ASI No. 9 – Stabilize Phase 1A Masonry Wall

TO : Conventional Builders
FROM : Dan Shurina
DATE : 01/31/24
REFERENCE : 19121 East Wing HVAC Replacement at DelDOT Admin Bldg

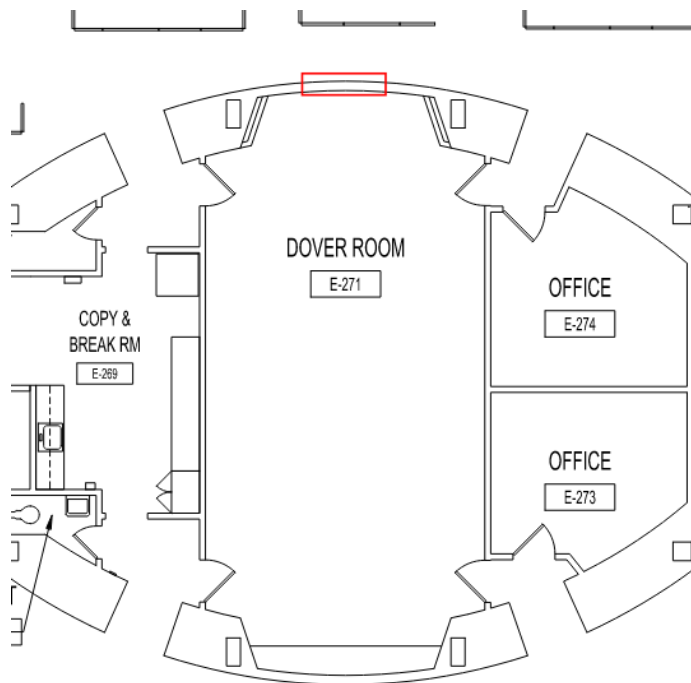
Demolish and remove courses of masonry above damaged existing opening above ceiling in the area of the red square indicated below. Opening to remain for new 14”X10” SA duct.
